ARCHITECT'S ADDENDUM

Addendum Number: 008

RE: KANE COUNTY - Multi-Use facility

Subject: Addendum No. 008 to the Construction Documents for the Kane County Multi-Use Facility.

KANE CO MUF SANITARY SERVICE PLAN VIEW
SCALE: 1" = 40'

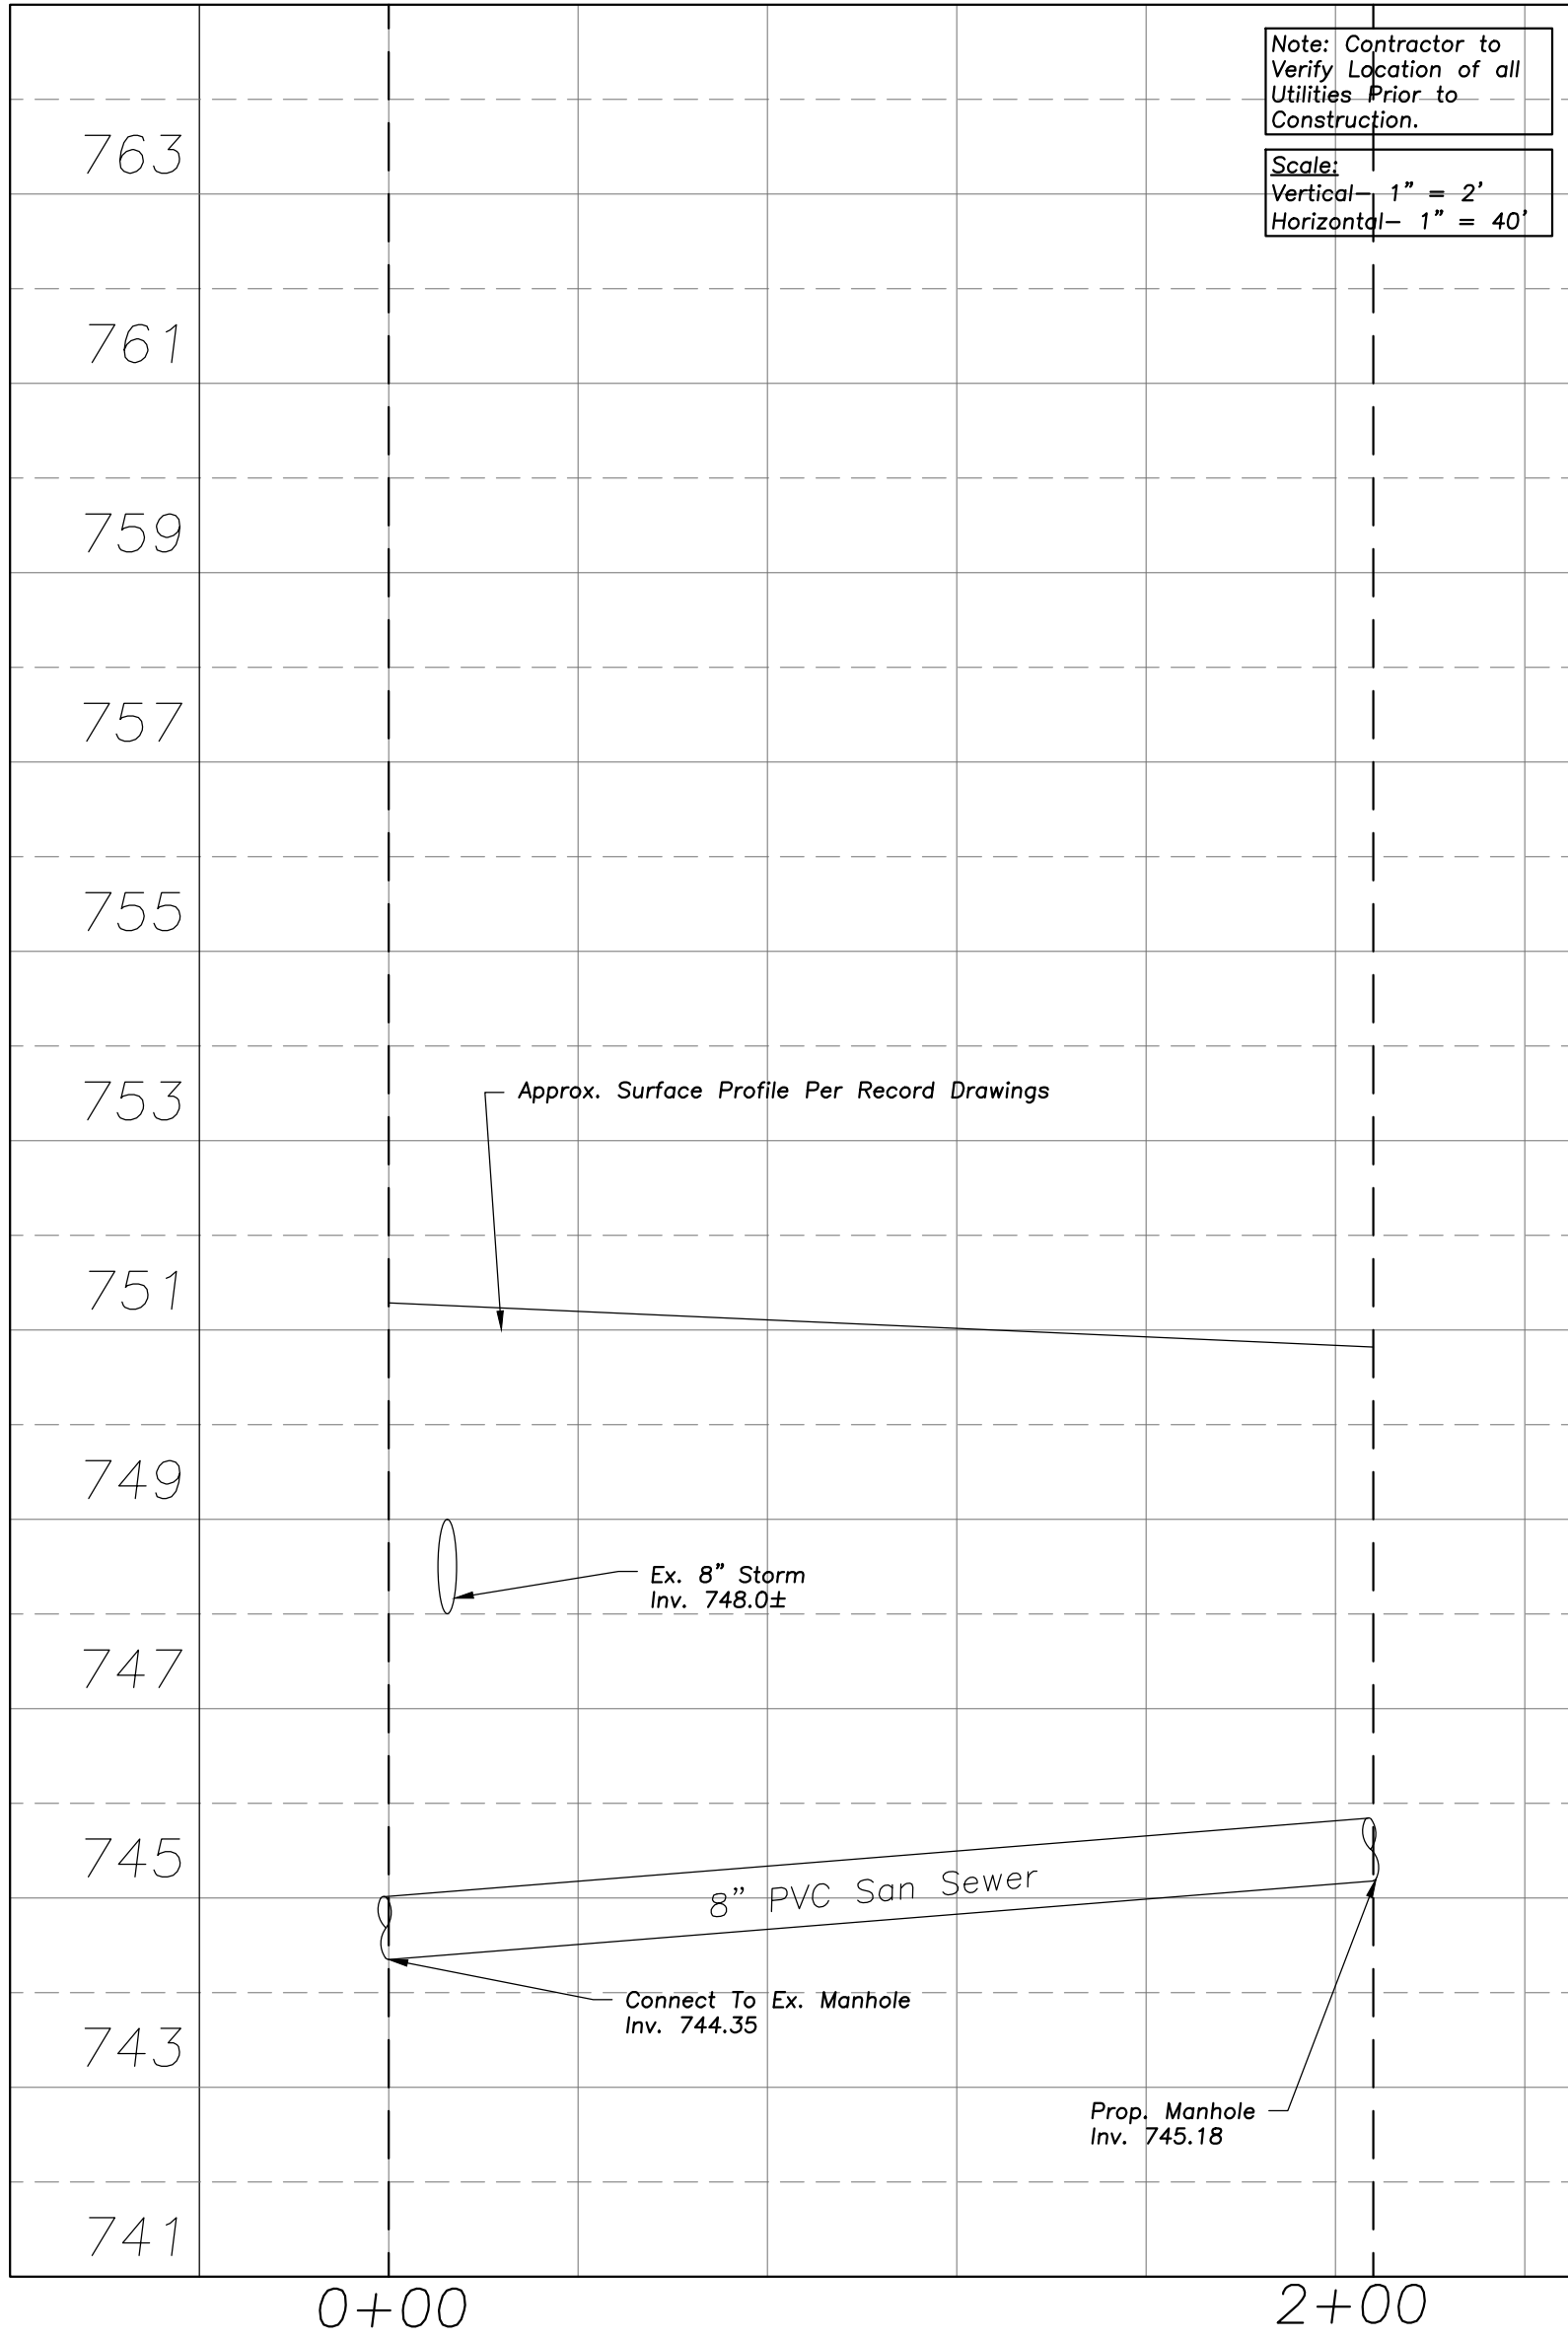
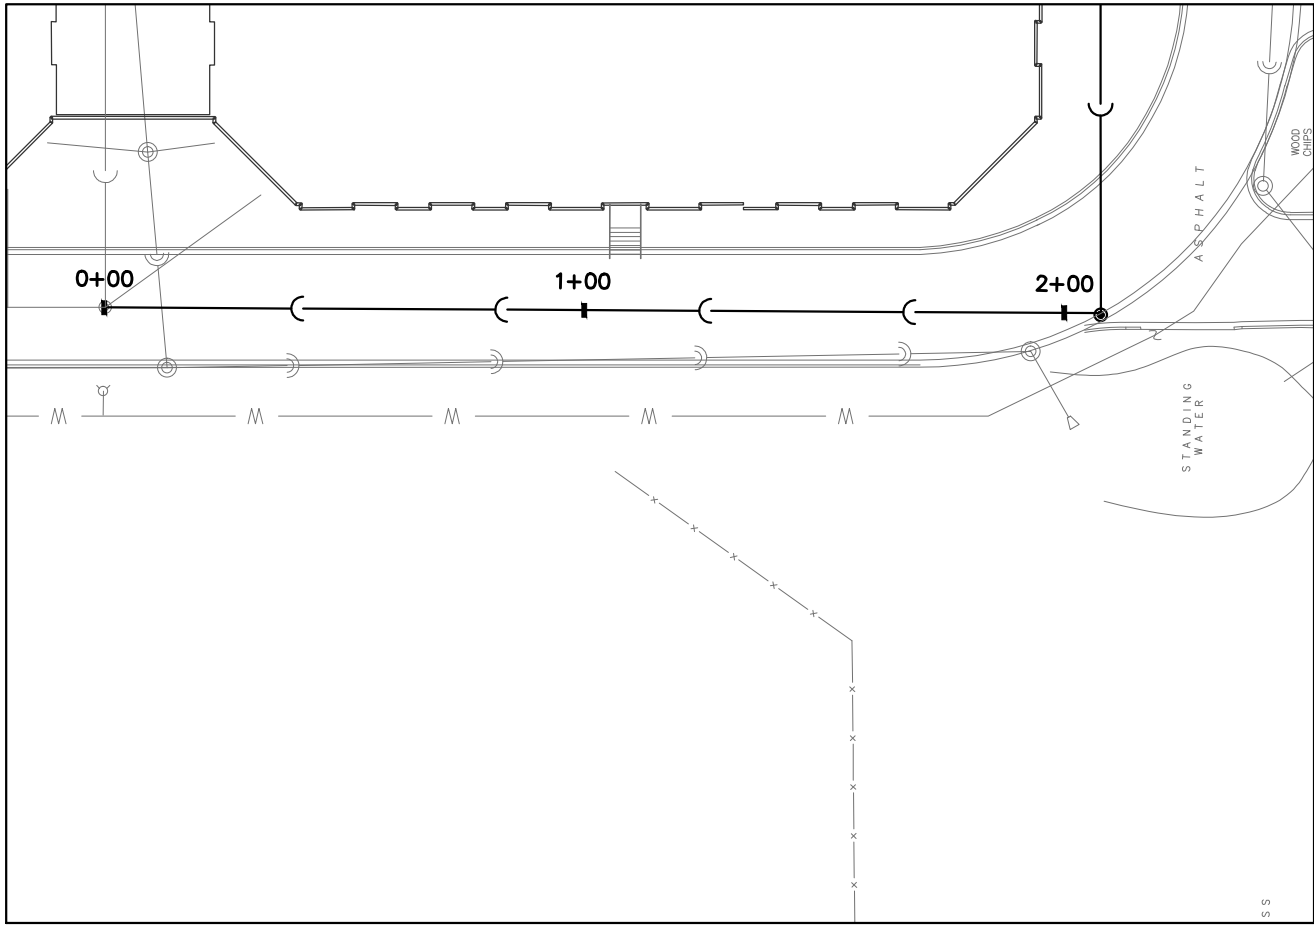
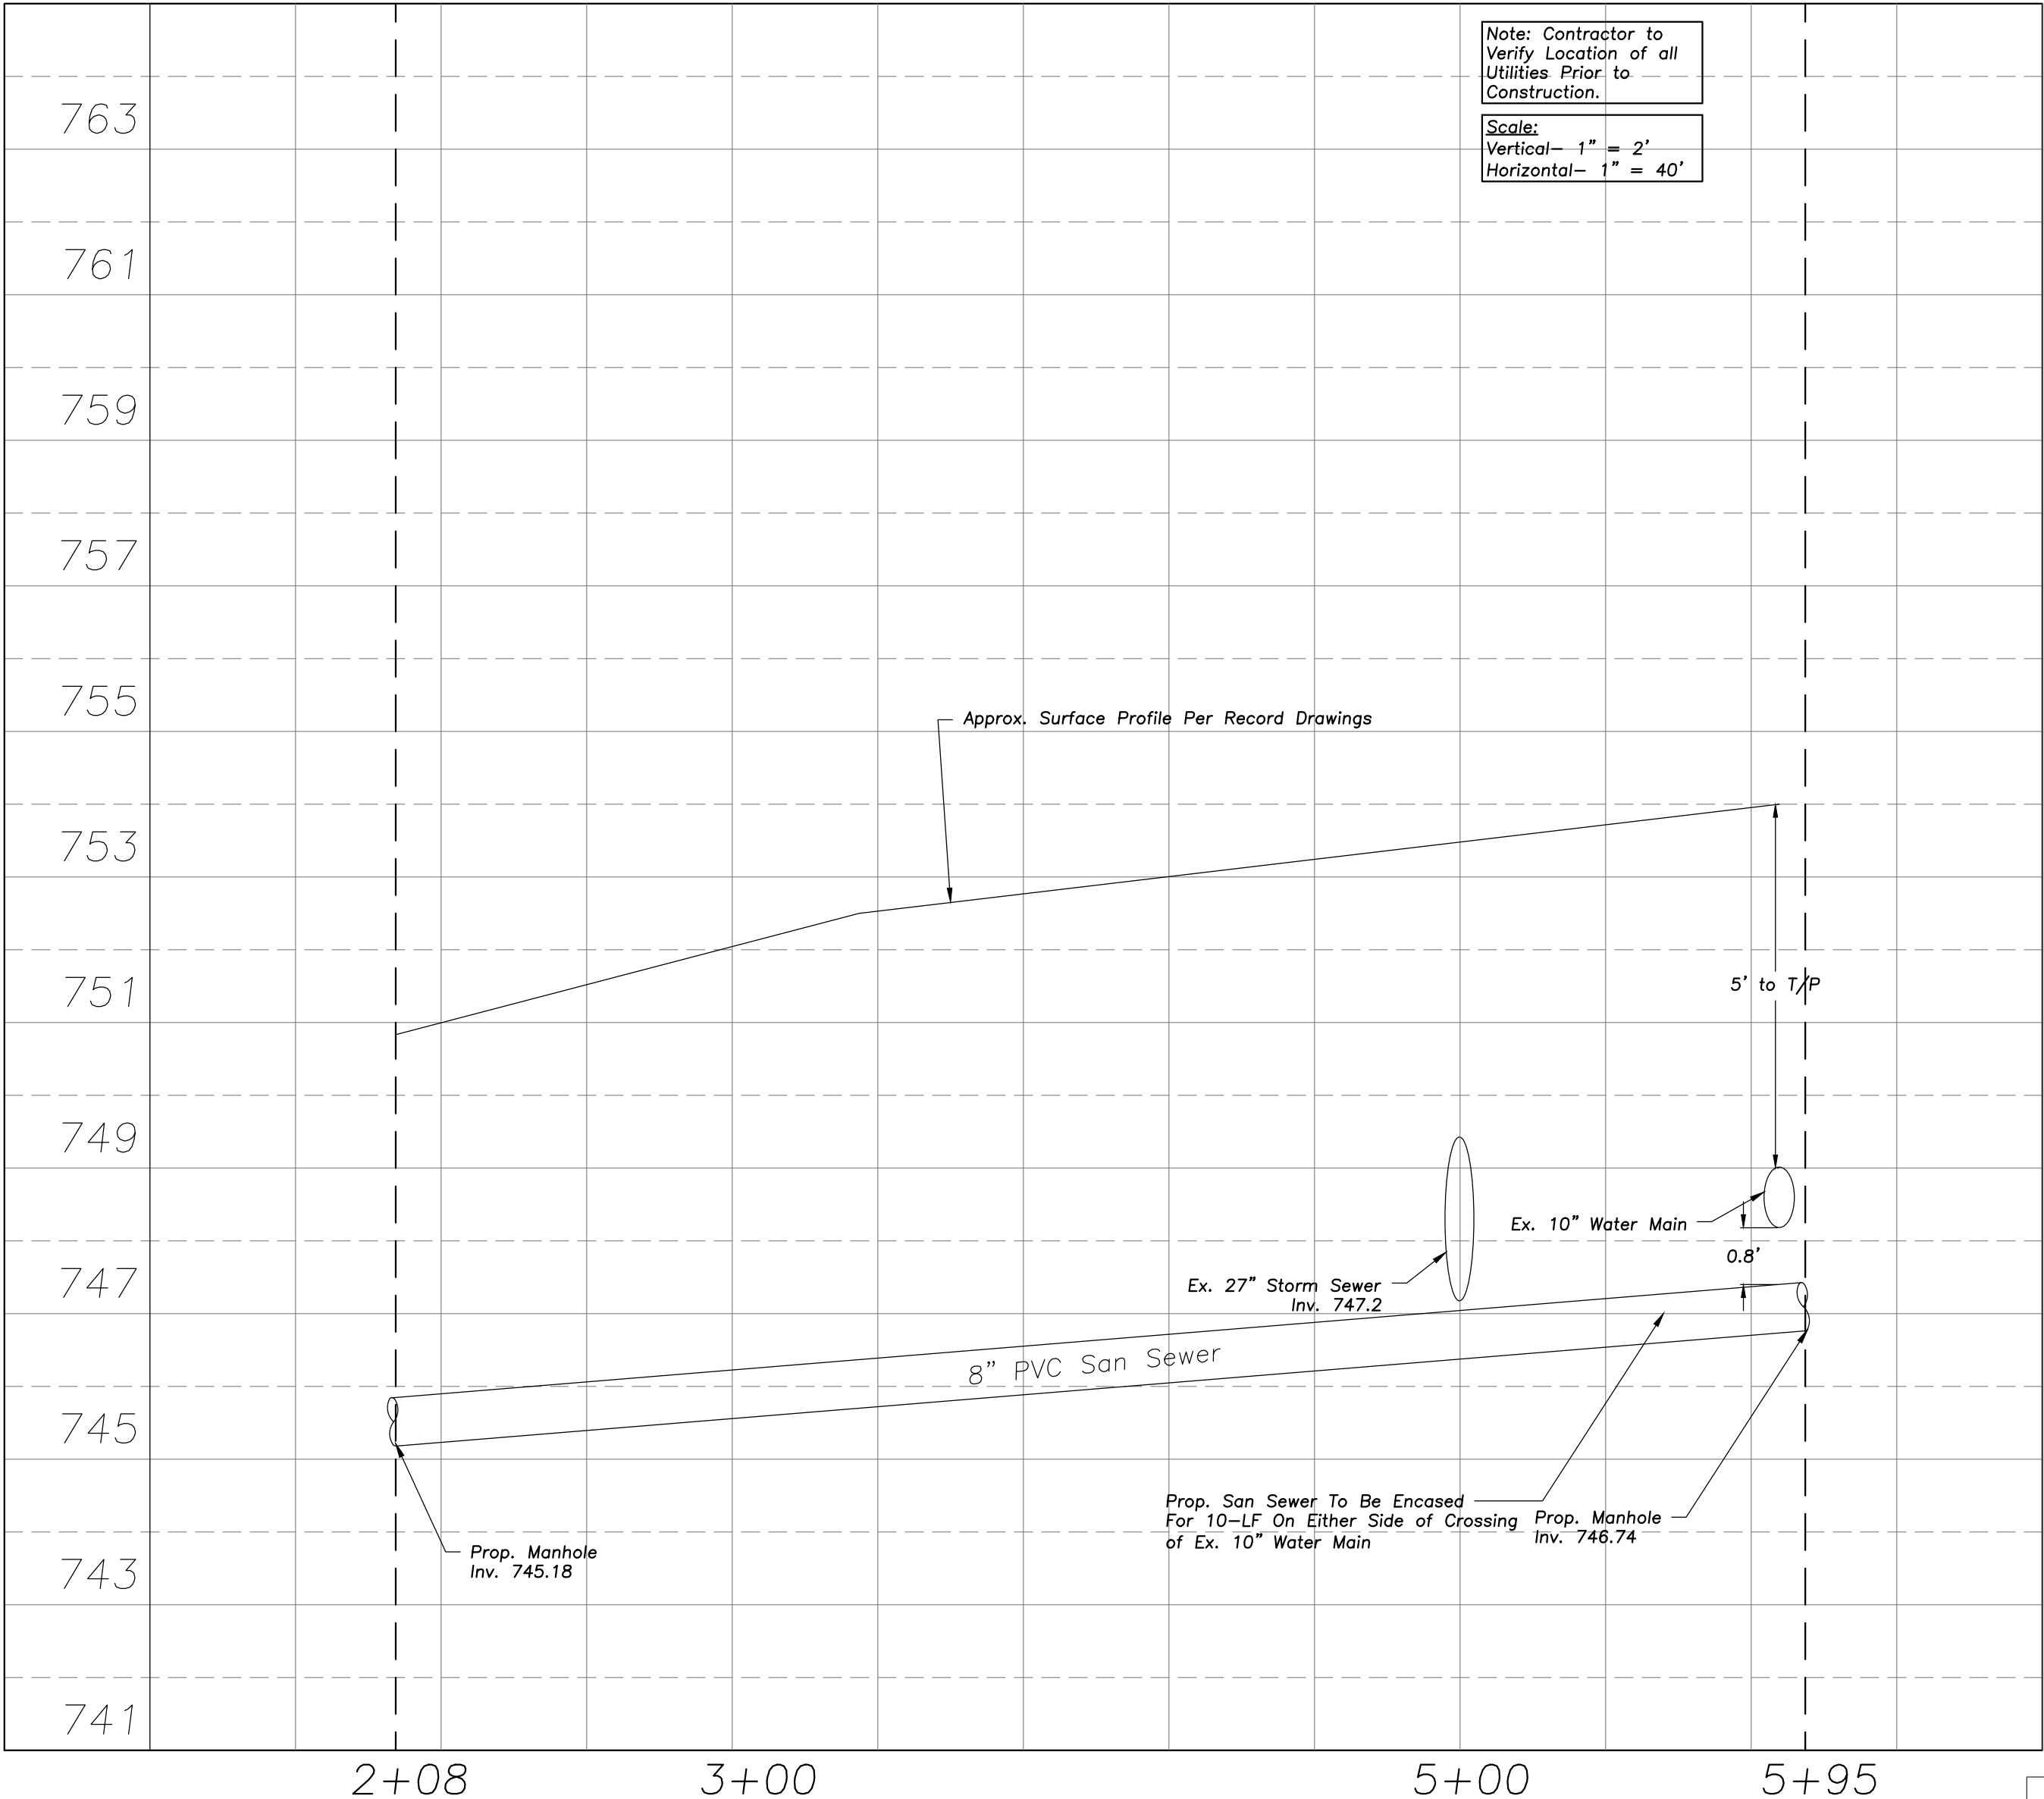
- C3.1 Site Utility Plan
- C6.0 Sanitary Sewer Plan and Profile
- C6.1 Sanitary Sewer Plan and Profile
